# Access Compliance Report

## Public Rights-of-Way

Intersection ID: 3928	Main Street: BICKHAM_LN	Cross Street: KIRKGARD_TL	Location:	N
ADA ID: 506A5A826EB3	Ramp Type: Perp	Initial Pass/Fail: Fail	Overall Compliance: No	Severity Score: 22.5
Codes/Mitigation Info/Possible Solution		Field Measurements/Component Compliance

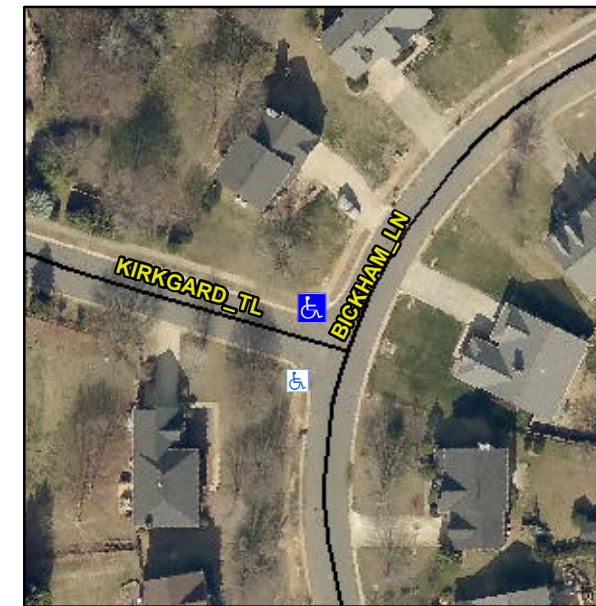
**Not Found, R304.5.1, R304.2.2, R304.5.3**

Compliance	Description	Data	Compliance	Description	Data
N/A	Ramp Length (in)	30.5	No	Ramp Slope (%)	9.0
No	Ramp Width (in)	40.0	No	Ramp XSlope (%)	2.4
N/A	Flare Type LT	N/A	N/A	Flare Type RT	N/A
N/A	Flare Slope LT (%)	N/A	N/A	Flare Slope RT (%)	N/A
N/A	Flare Traversable LT?	N/A	N/A	Flare Traversable RT?	N/A
N/A	Landing Length (in)	N/A	N/A	DWS Provided?	N/A
N/A	Landing Width (in)	N/A	N/A	DWS Contrast?	N/A
N/A	Landing Slope (%)	N/A	N/A	DWS Length (in)	N/A
N/A	Landing X Slope (%)	N/A	N/A	DWS Full Width?	N/A
N/A	Landing Curb? (Y/N)	N/A	N/A	DWS Offset (in)	N/A
N/A	Shared Landing?	N/A			
N/A	Gutter Ponding?	N/A	N/A	Gutter Slope (%)	N/A
N/A	Gutter Lip Ht (in)	N/A	N/A	Gutter X Slope (%)	N/A
N/A	Painted X Walk1?	No	N/A	Painted X Walk2?	N/A
	X Walk 1 Direction	To SW		X Walk 2 Direction	N/A
N/A	X Walk 1 Width (in)	N/A	N/A	X Walk 2 Width (in)	N/A
	X Walk 1 Slope (%)	3.9		X Walk 2 Slope (%)	N/A
	X Walk 1 X Slope (%)	0.6		X Walk 2 X Slope (%)	N/A

**Remove & Replace Entire Ramp.**
